## SERVICE BULLETIN

**APPLICABILITY:** 2013MY BRZ **NUMBER:** 15-158-12  
**SUBJECT:** Navigation/GPS Antenna Changes **DATE:** 10/24/12  
 SD Card Exchange Program Information

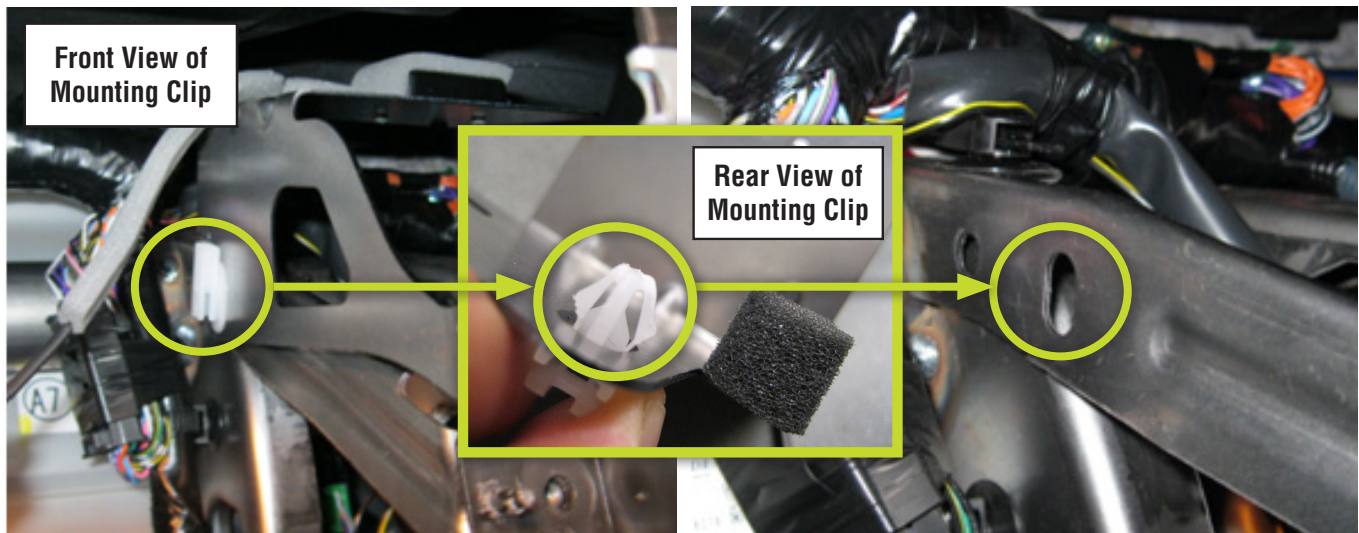
The photo below shows the revised GPS antenna / mounting bracket assembly along with an antenna lead extension harness already attached. **NOTE:** The revised GPS antenna / mounting bracket assembly you receive may have a longer 1-piece lead instead of a shorter lead with an extension pigtail as shown in the photo. Either configuration is acceptable to use for this procedure.

Install the revised GPS antenna / mounting bracket assembly. Confirm the white plastic mounting clip locks into the large oblong hole in the instrument panel support bracket properly before installing the mounting screw. **CAUTION:** Do not over-tighten the mounting screw.
